HISTORIC AND DESIGN REVIEW COMMISSION

December 06, 2017

HDRC CASE NO: 2017-592
ADDRESS: 152 E PECAN ST
LEGAL DESCRIPTION: NCB 403 BLK 14 LOT N48 OF 11
ZONING: D, HS
CITY COUNCIL DIST.: 1
LANDMARK: Builder's Exchange Building
APPLICANT: Michael Sohocki/Restaurant Gwendolyn
OWNER: Exchange Group 1992, LTD
TYPE OF WORK: Installation of awnings, canopy railings and exterior lighting
APPLICATION RECEIVED: November 13, 2017
60-DAY REVIEW: January 12, 2018
REQUEST:

102 detail

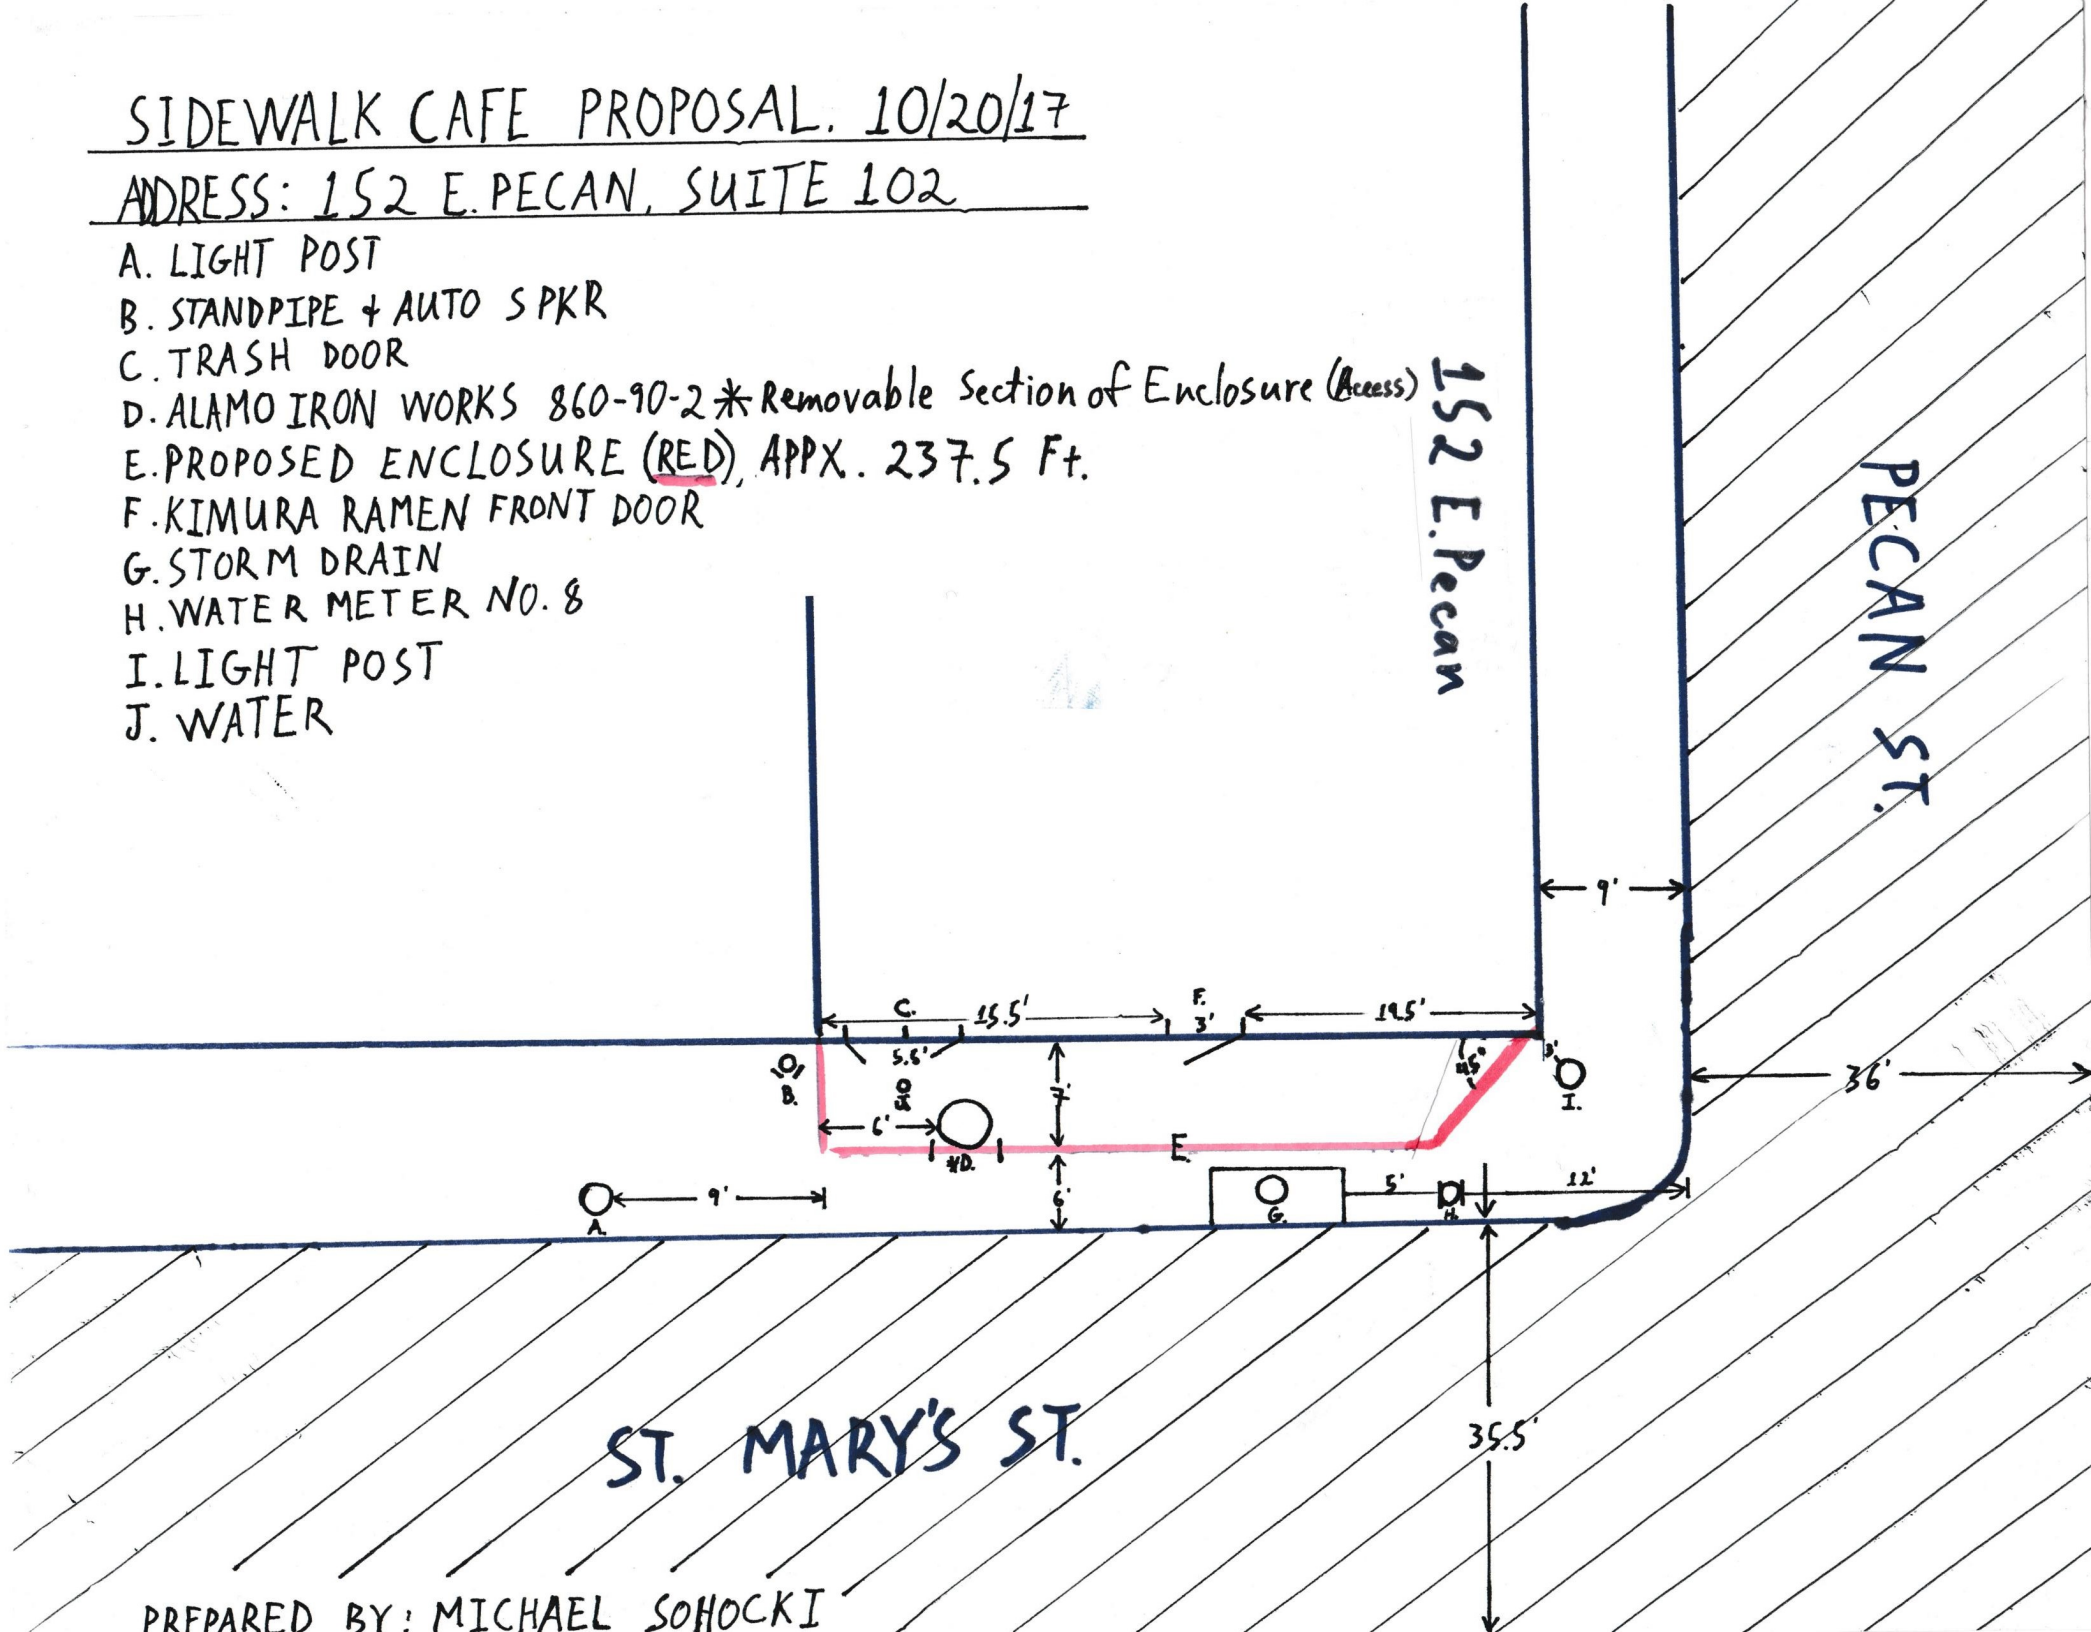
- b. **AWNINGS** – The applicant has proposed to install three black awnings to cover the three transom openings above the storefront system on the N St Mary's façade. Per the Guidelines for Exterior Maintenance and Alterations, new canopies and awnings should be based on accurate evidence of the original, such as photographs. If no such evidence exists, the design of new canopies and awnings should be based on the architectural style of the building and be proportionate in shape and size to the scale of the building façade to which they will be attached. Based on evidence of the building design and an existing metal canopy on the Pecan facade of the building, staff does not find that a fabric awning would have likely existed historically. Staff finds a flat canopy is historically accurate and would be more appropriate.

- d. **RAILINGS** – To enclose the outdoor seating area proposed on the N St Mary's sidewalk, the applicant has proposed to install metal railings to feature 41 inches in height. Railings for outdoor seating are not common on N St Mary's; however, they are found commonly on other streets throughout downtown San Antonio. Staff finds this installation as well as the profile, which matches that found on the river façade of this structure to be appropriate. Six feet of sidewalk clearance will remain.

- e. **LIGHTING** – The applicant has proposed to install string lighting to be attached to the proposed awnings, railings and to extend from the façade of the structure to the existing traffic signal pole. Staff finds the installation of lighting on the proposed railings to be appropriate; however, staff does not find the proposed installation of awning lighting or lighting to extend to traffic infrastructure to be appropriate.

Staff does not recommend approval of item #1, the installation of awnings based on finding b.

Staff recommends approval of items #2 and #3, the installation of street furnishings and railings based on finding c and d.

Staff recommends approval of item #4, the installation of lighting only on the railings noted in request item #3. Staff does not recommend approval of lighting on proposed awnings or to extend to traffic infrastructure.
